Subject: AP1000 COL Standard Technical Report Submittal of APP-GW-GLN-019, Revision 2 (TR 103)

The changes within this Technical Report are a compilation of approved design changes to AP1000 Fluid Systems that have not previously been submitted under individual header. This document is sectioned to identify Fluid System changes that have been approved by the Westinghouse Change Control Board, that have not been submitted in previous Technical Reports, and that have had a direct impact on the Design Control Document (DCD). These are predominantly minor changes in system designs that are due to the progression of the detailed design. Each change will be individually identified within this document. The description of these changes can be found within Section II of this document. Additionally, not all of the changes described within this document have been incorporated into Rev. 16 of the AP1000 Design Control Document. The changes to R16 are detailed on pages 144 to 149.

Title: Fluid System Changes

Figure 6.2.2-1 (Sheet 1 of 2)
 Passive Containment Cooling System
 Piping and Instrumentation Diagram
 (REF) PCS 001

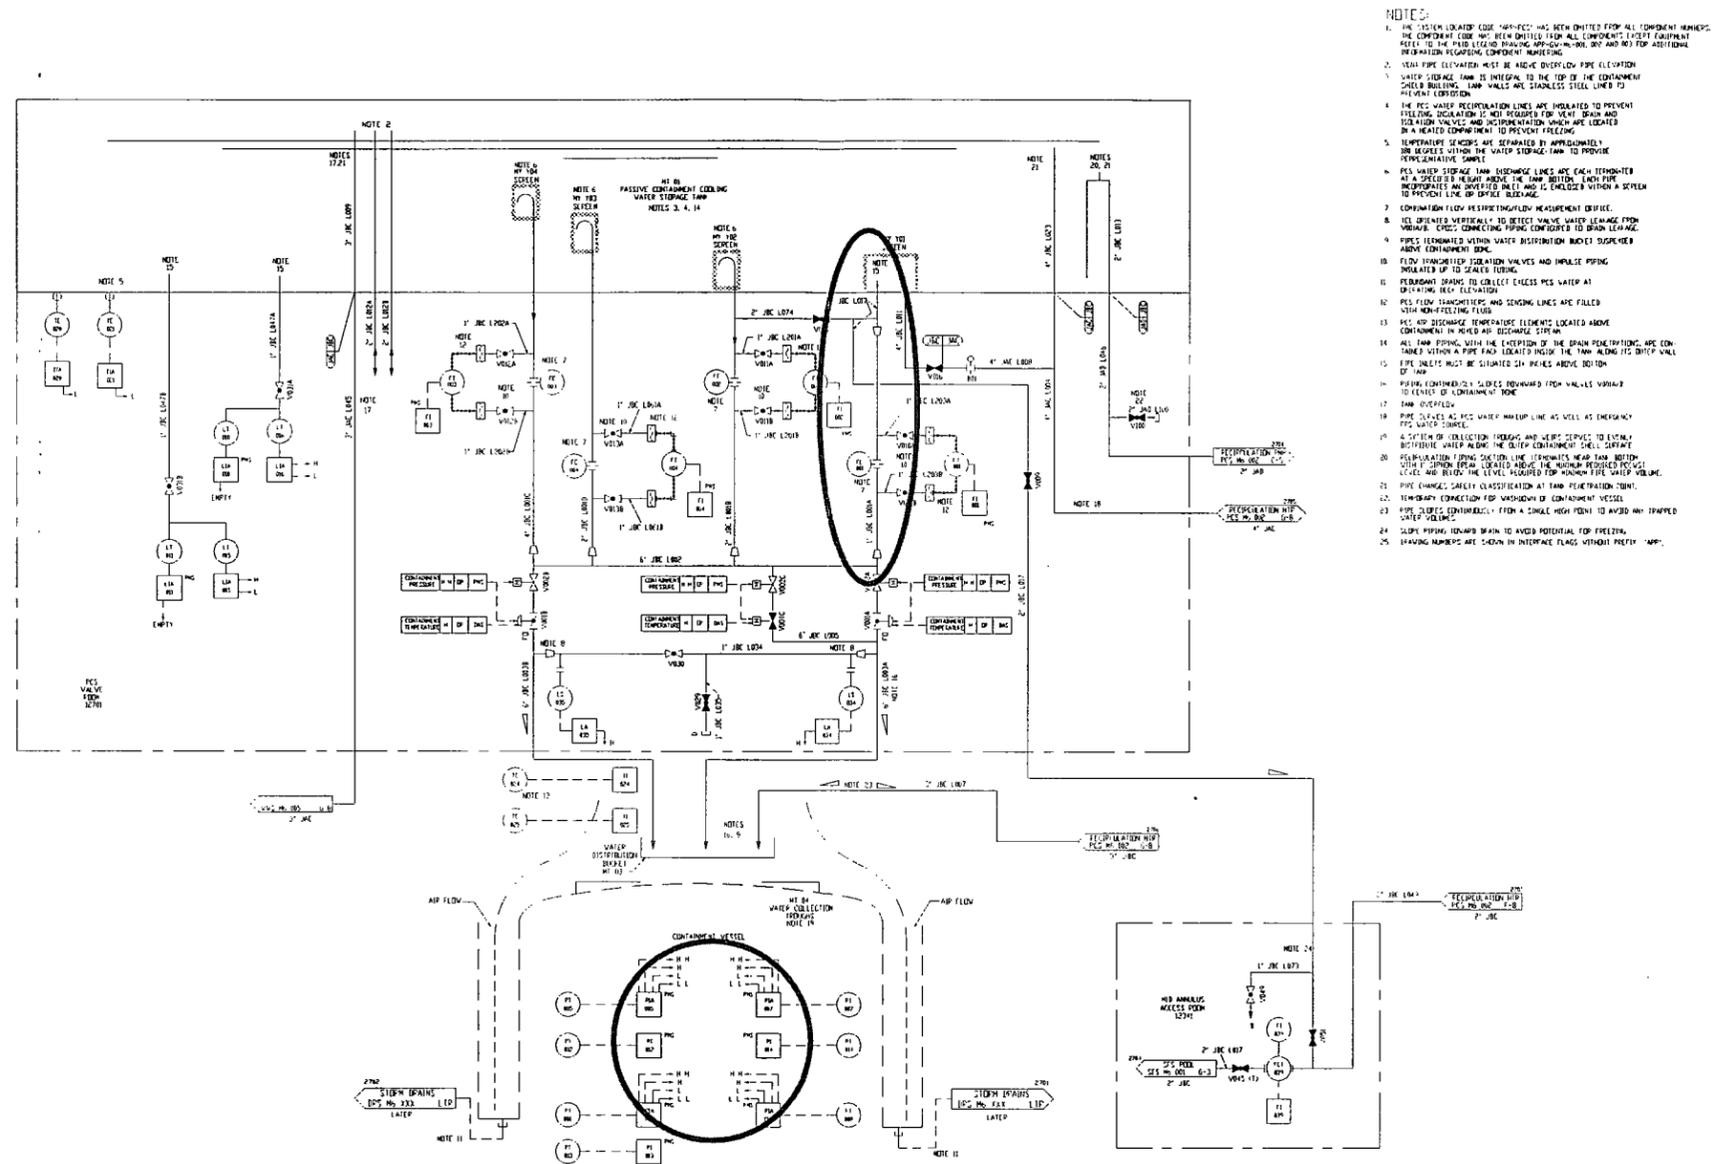
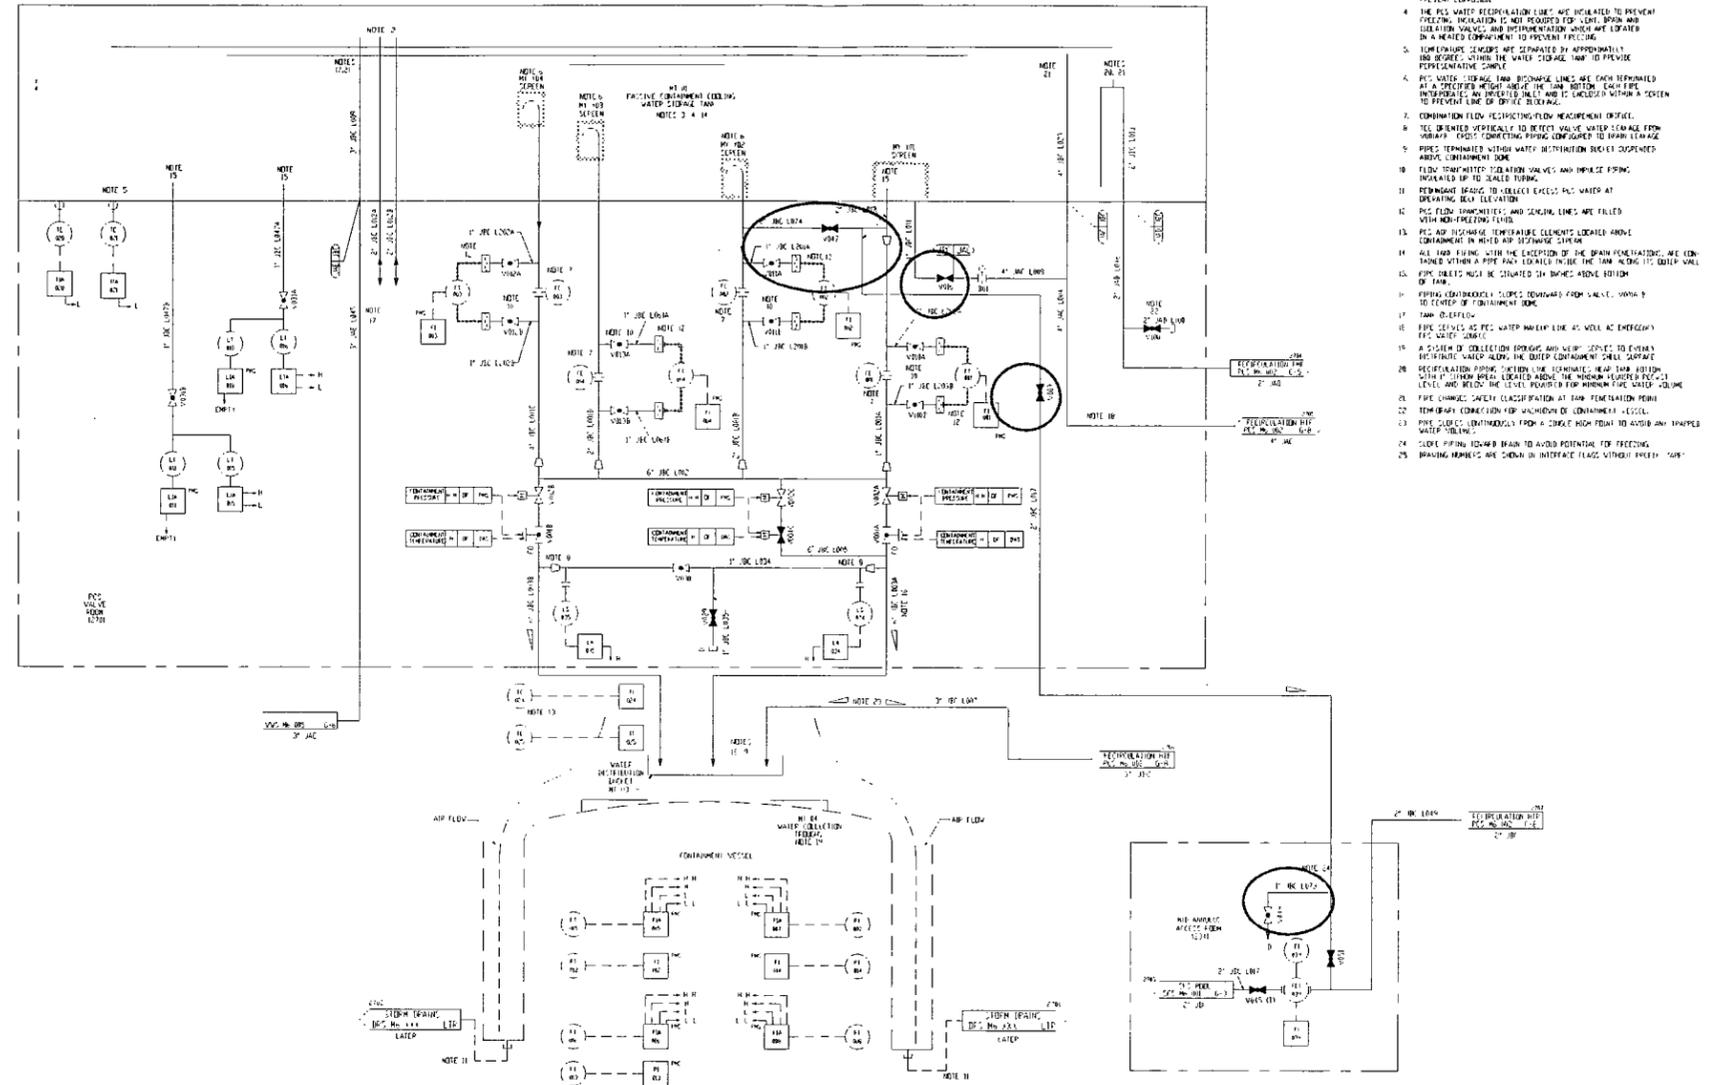
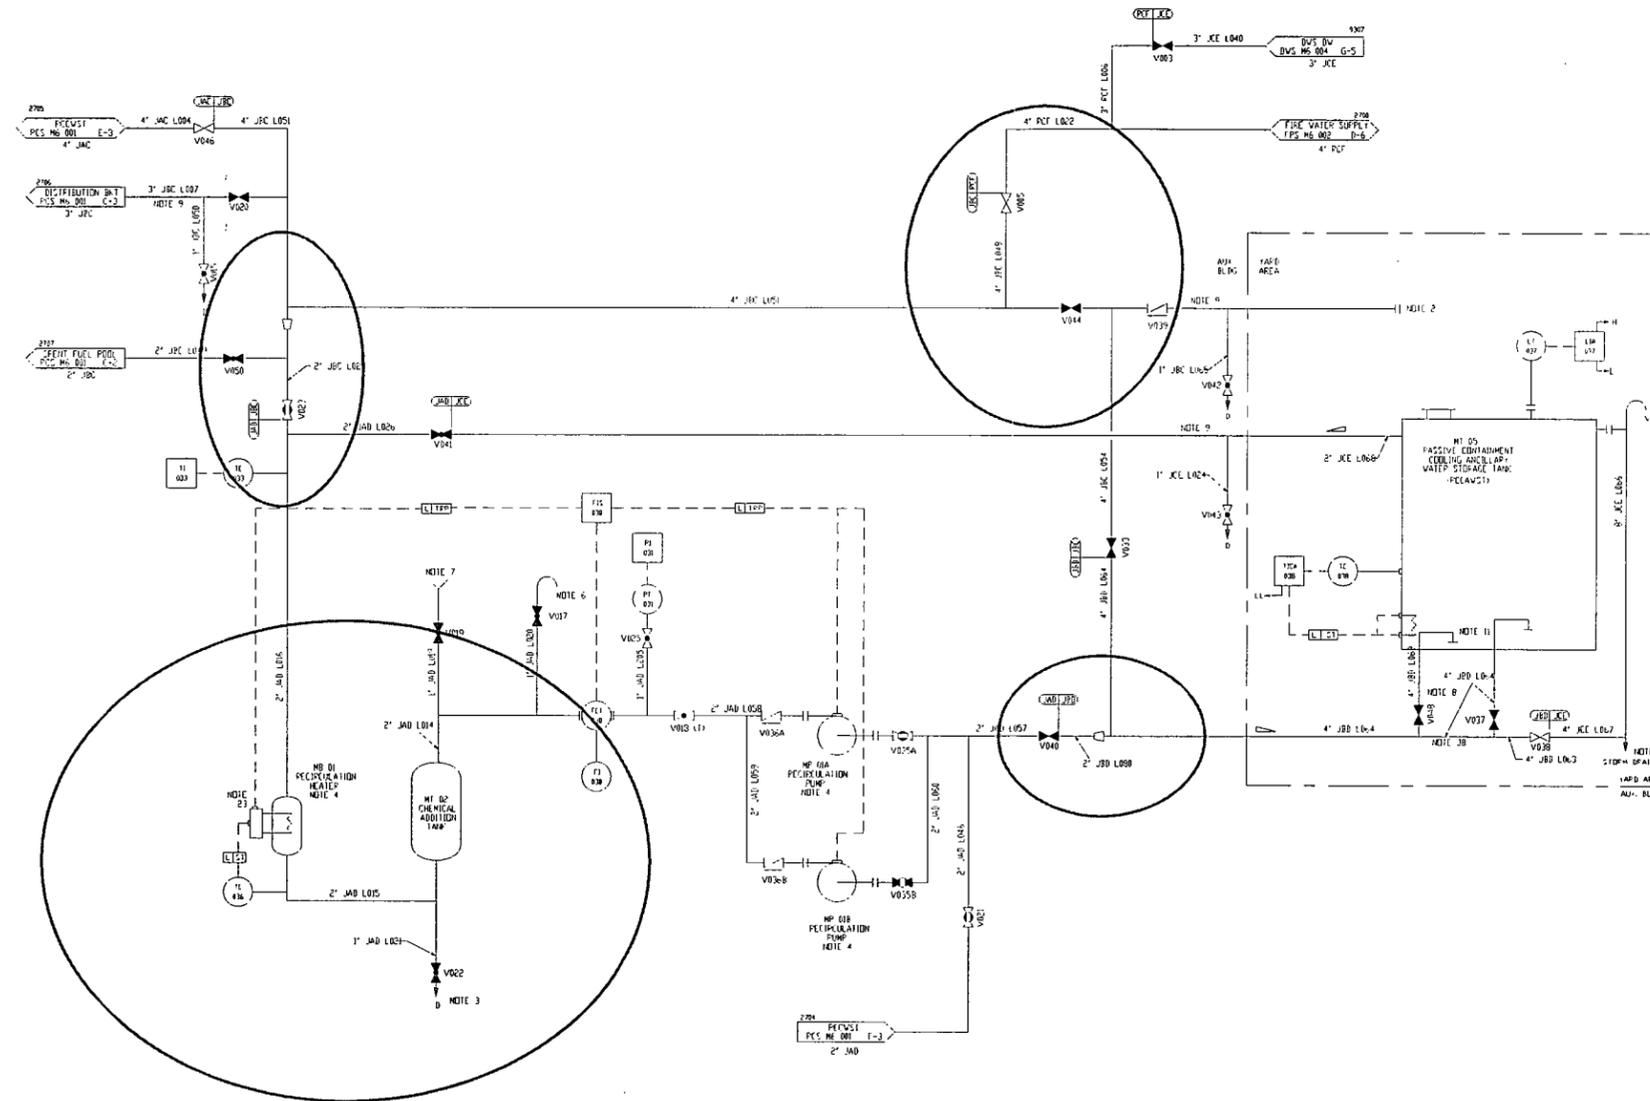
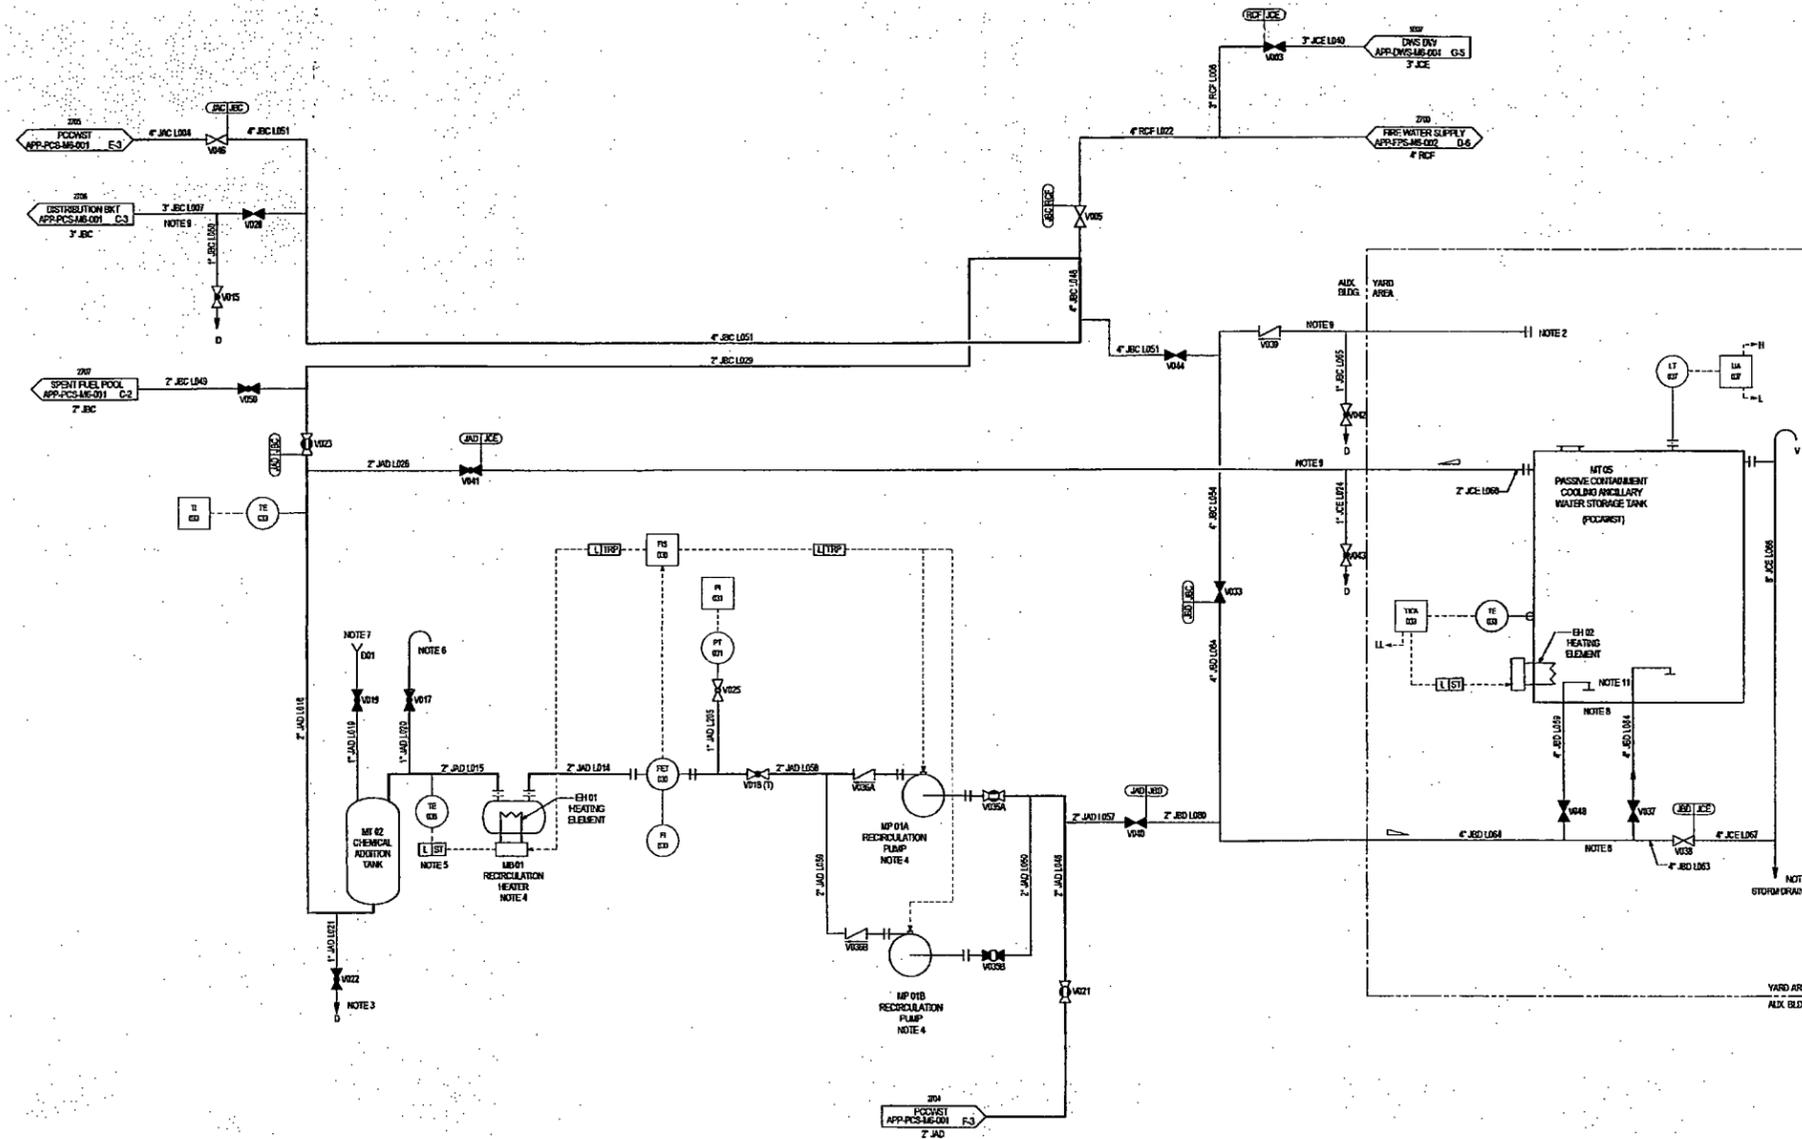
The lines APP-PCS-PL-L017 and APP-PCS-PL-L001A have been changed to a single 3 inch line; this change has been made to make it possible to achieve the flow rates required for adequate containment cooling. The reducer has been removed to allow for proper flow of PCS water to the containment shell once the flow measuring/limiting orifice has been tuned. This correction to the design allows the system to meet the requirements set forth in the DCD; this is not a functional change to the system.

Pressure indicators 005, 006, 007 and 008 were shown as pressure indicators with alarms. The instrument tags have been corrected to show that they also have a control that opens the containment cooling valves.

Section III contains a markup of changes to DCD Figure 6.2.2-1.
